ATTACHMENT NO. 1 TO AEP:NRC:0894

TECHNICAL SPECIFICATION CHANGE DESCRIPTIONS

Change No. 1

FIGURE 3.4-2

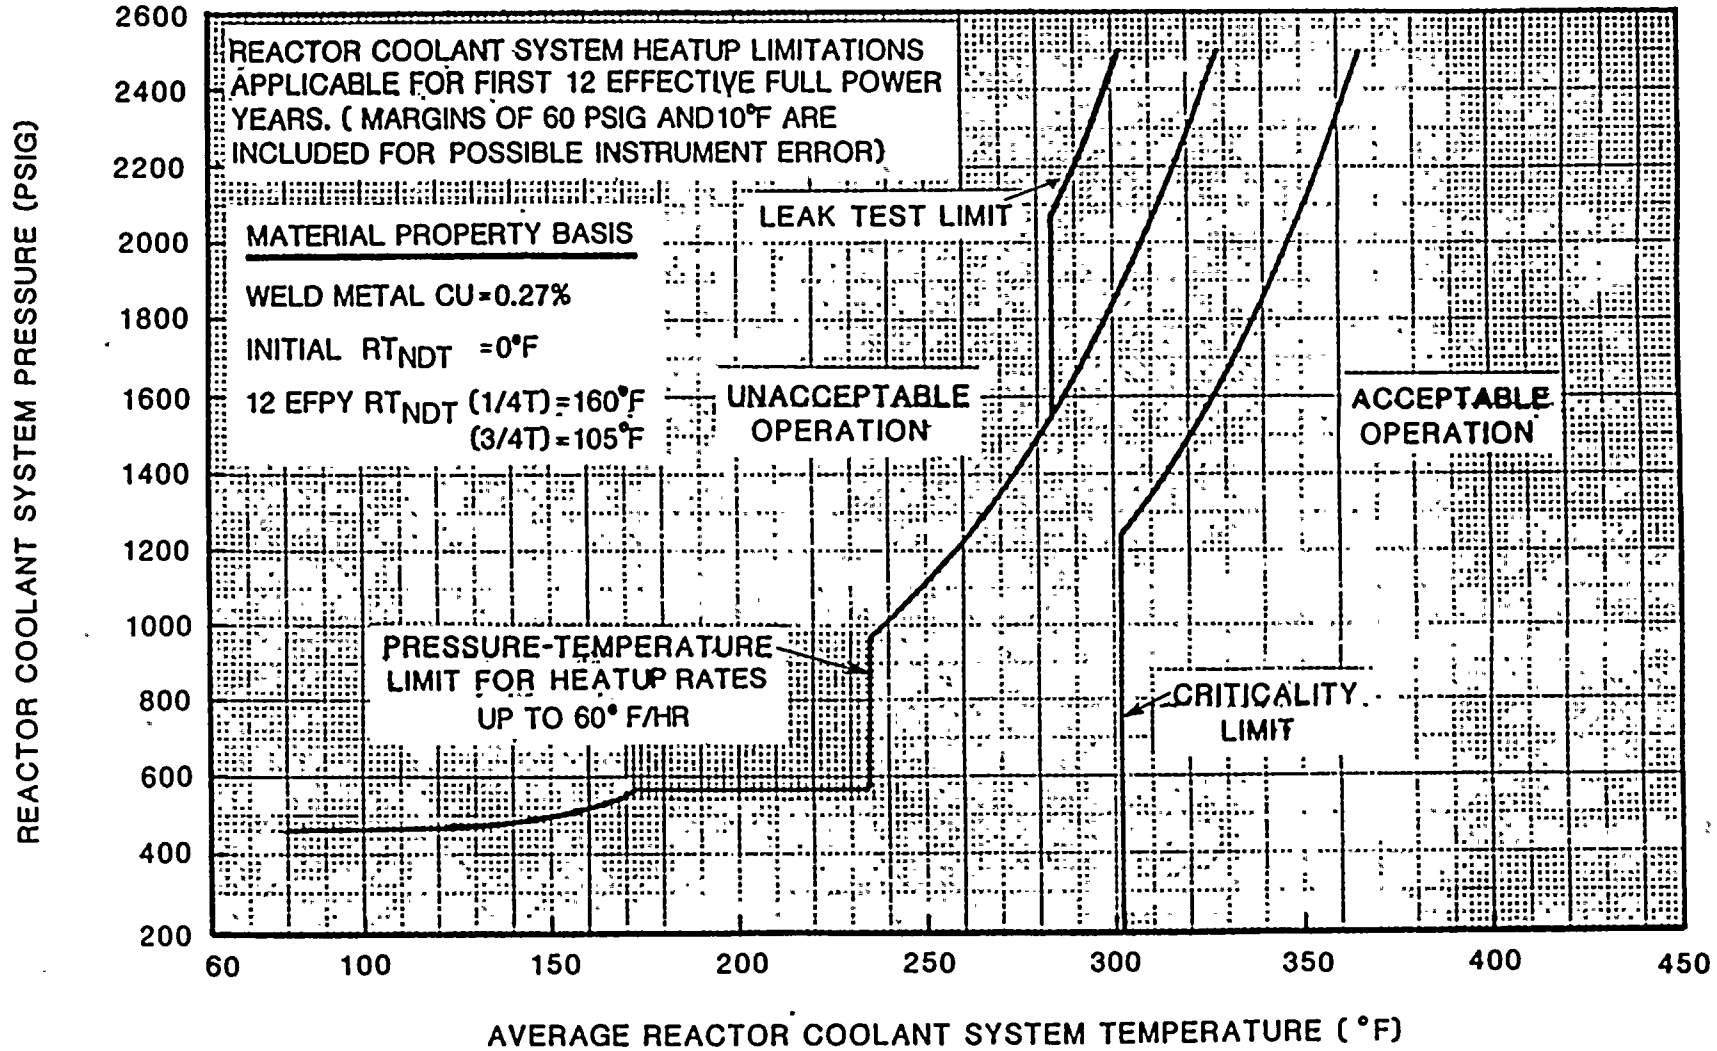
Figures 3.4-2 and Figure 3.4-3 are the heatup and cooldown curves for Unit Nos. 1 and 2. These curves are composite curves prepared based upon the most limiting value of the predicted adjusted reference temperature at the end of 12 EFY. The revisions to the curves reflect the analyses done as a result of the capsule (Y) testing by Southwest Research Institute. The assumptions and limitations used in the development of the curves are noted in the revised bases for both Units.

The heatup limit curve, Figure 3.4-2, is a composite curve which was prepared by determining the most conservative case, with either the inside or outside wall controlling, for any heatup rate up to 60°F per hour. The cooldown limit curves of Figure 3.4-3 are composite curves which were prepared based upon the same type analysis with the exception that the controlling location is always the inside wall where the cooldown thermal gradients tend to produce tensile stresses while producing compressive stresses at the outside wall. The heatup and cooldown curves were prepared based upon the most limiting value of the predicted adjusted reference temperature at the end of 12 EFPY.

FIGURE 3.4-2

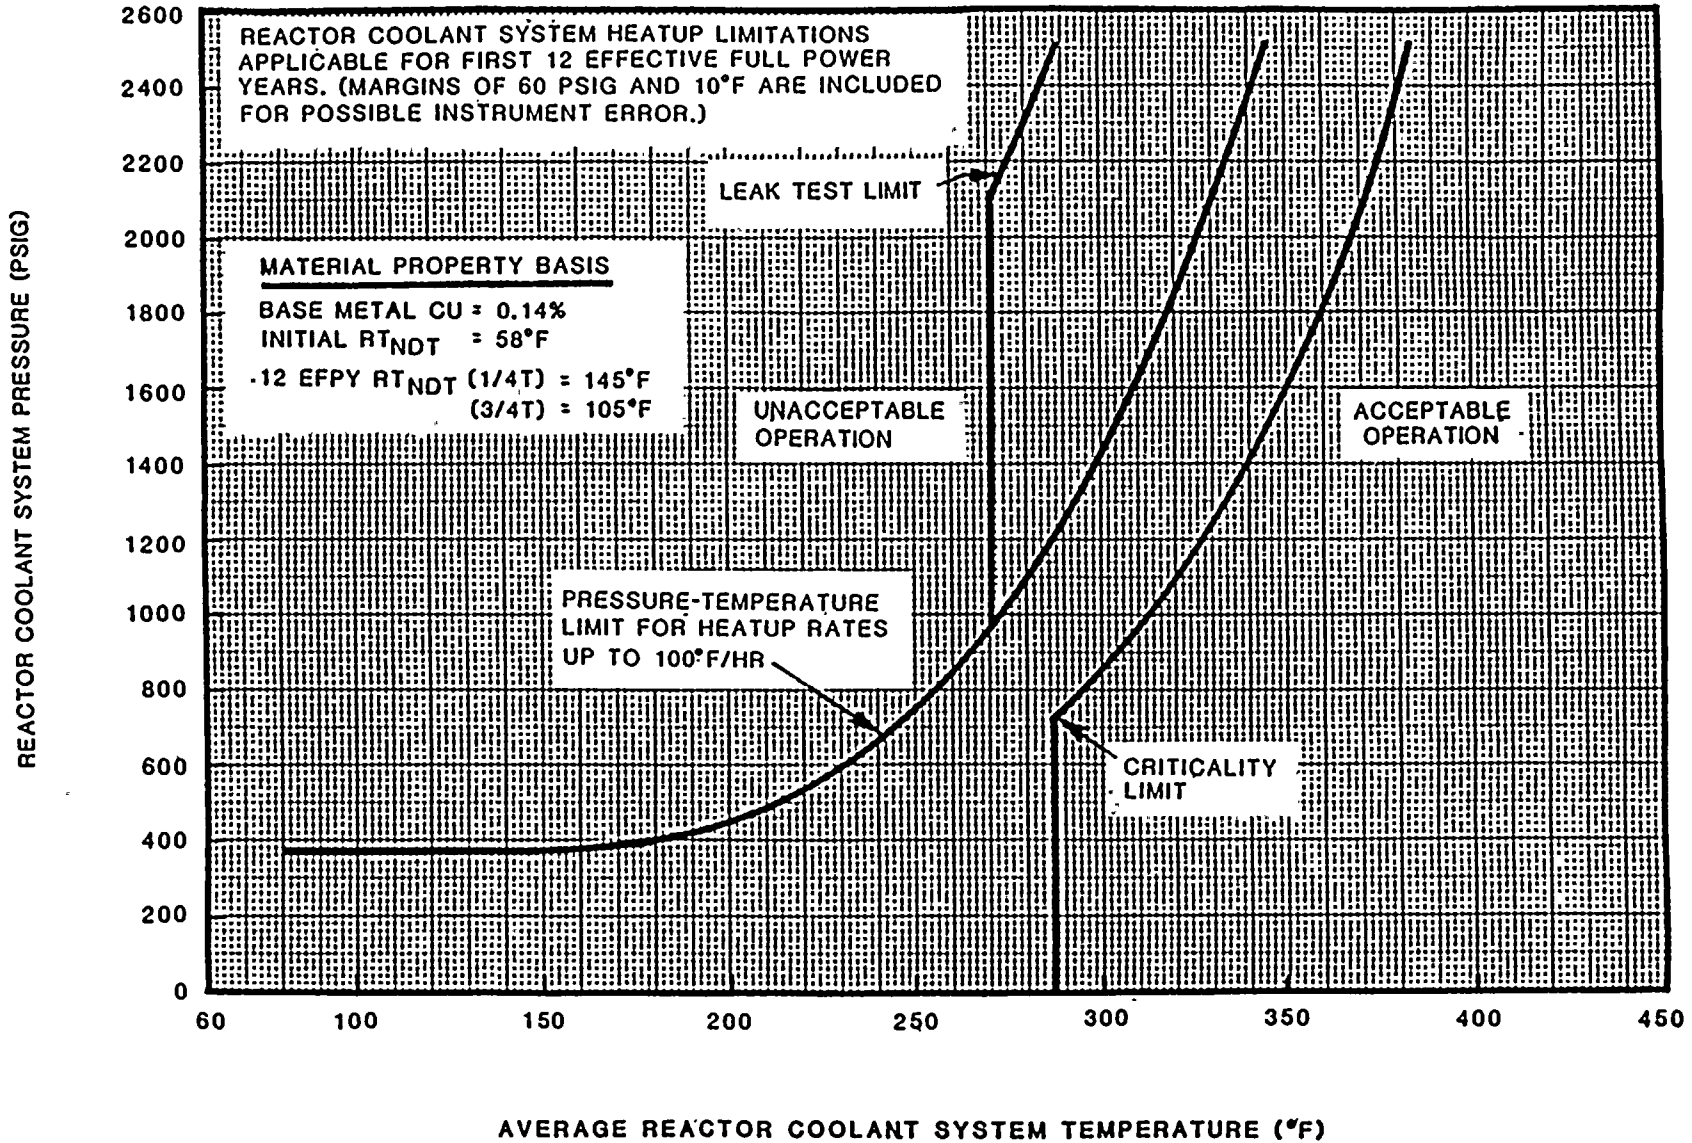
The heatup limit curve, Figure 3.4-2, is a composite curve which was prepared by determining the most conservative case, with either the inside or outside wall controlling, for any heatup rate up to 100°F per hour. The cooldown limit curves of Figure 3.4-3 are composite curves which were prepared based upon the same type analysis with the exception that the controlling location is always the inside wall where the cooldown thermal gradients tend to produce tensile stresses while producing compressive stresses at the outside wall. The heatup and cooldown curves were prepared based upon the most limiting value of the predicted adjusted reference temperature at the end of 12 EFPY.

FIGURE 1. PROPOSED MODIFICATION TO DONALD C. COOK UNIT NO. 1 REACTOR COOLANT SYSTEM PRESSURE-TEMPERATURE LIMITS VERSUS 60°F/HOUR RATE CRITICALITY LIMIT AND HYDROSTATIC TEST LIMIT, 12 EPFY, FOR FRACTURE CONTROL AT STRUCTURAL DISCONTINUITIES

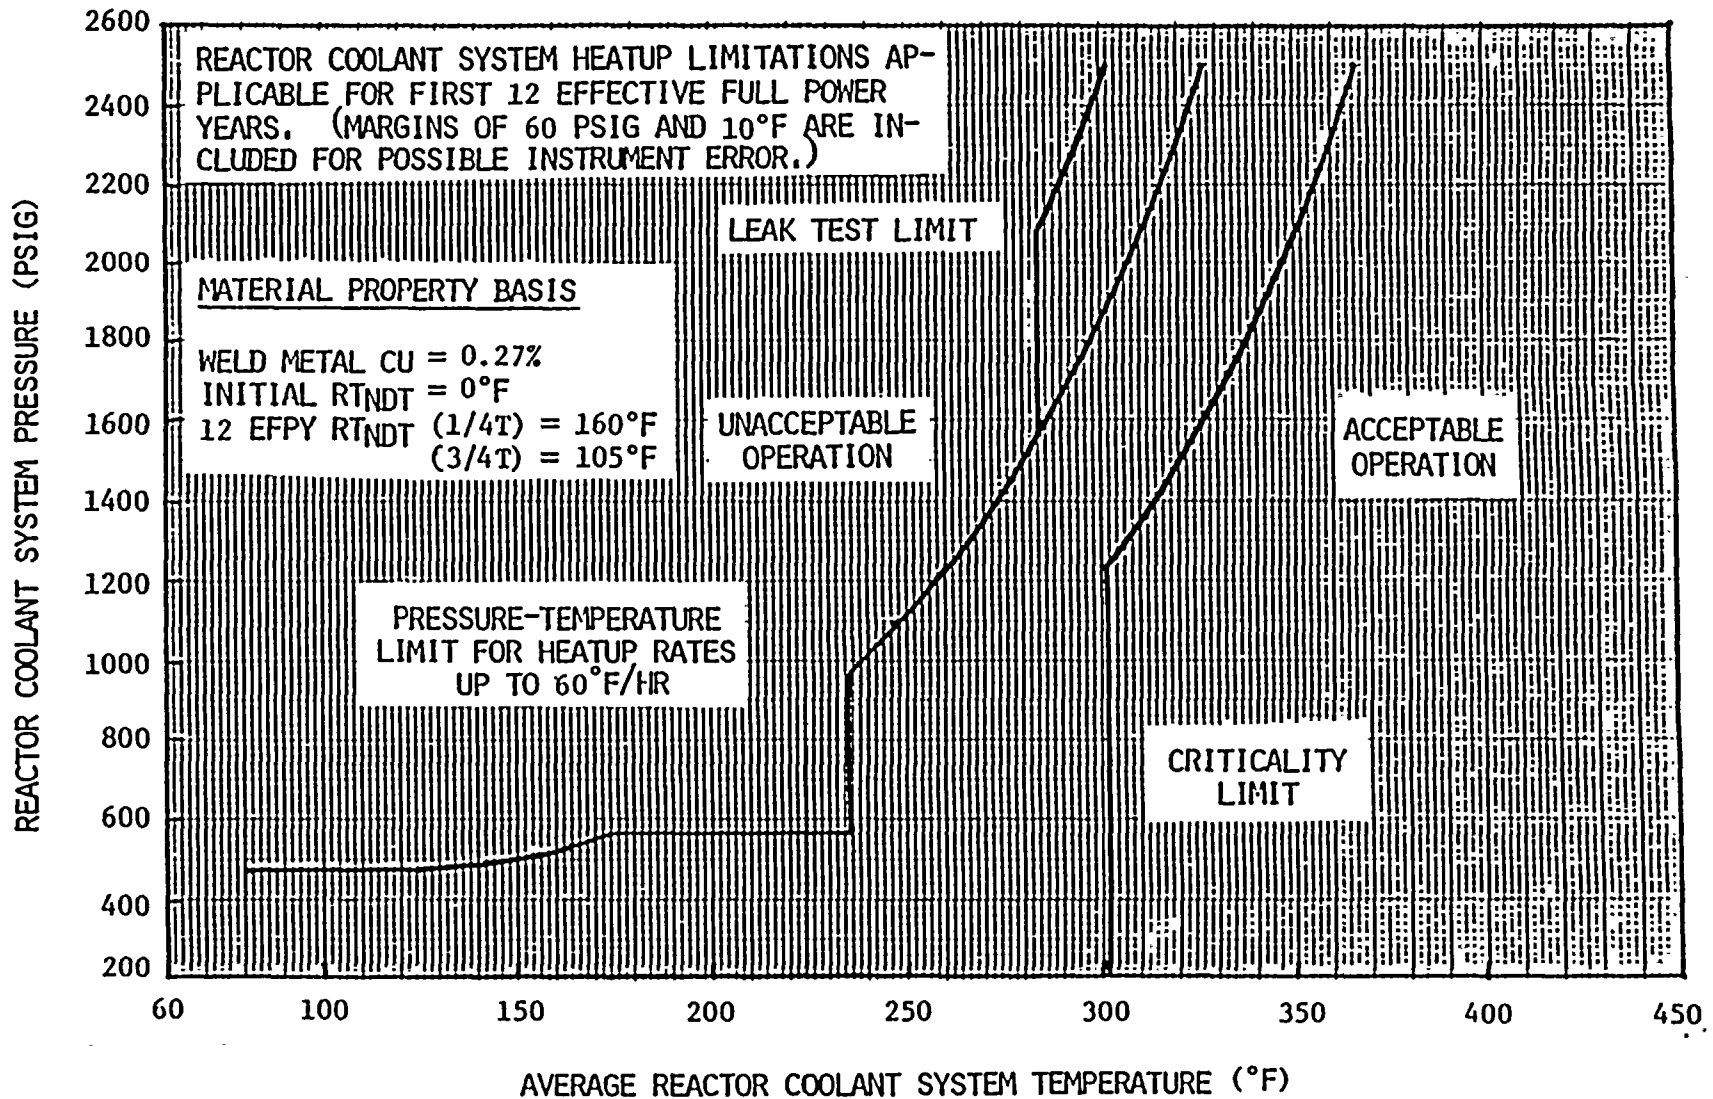
Enclosed is a revised Figure 1 for placement in the referenced letter. Although the 10°F allowance for instrument error had been included in the analysis described in the referenced letter, the -60 psi instrument error had not. Therefore, I lowered the horizontal line from 625 psi to 565 psi.
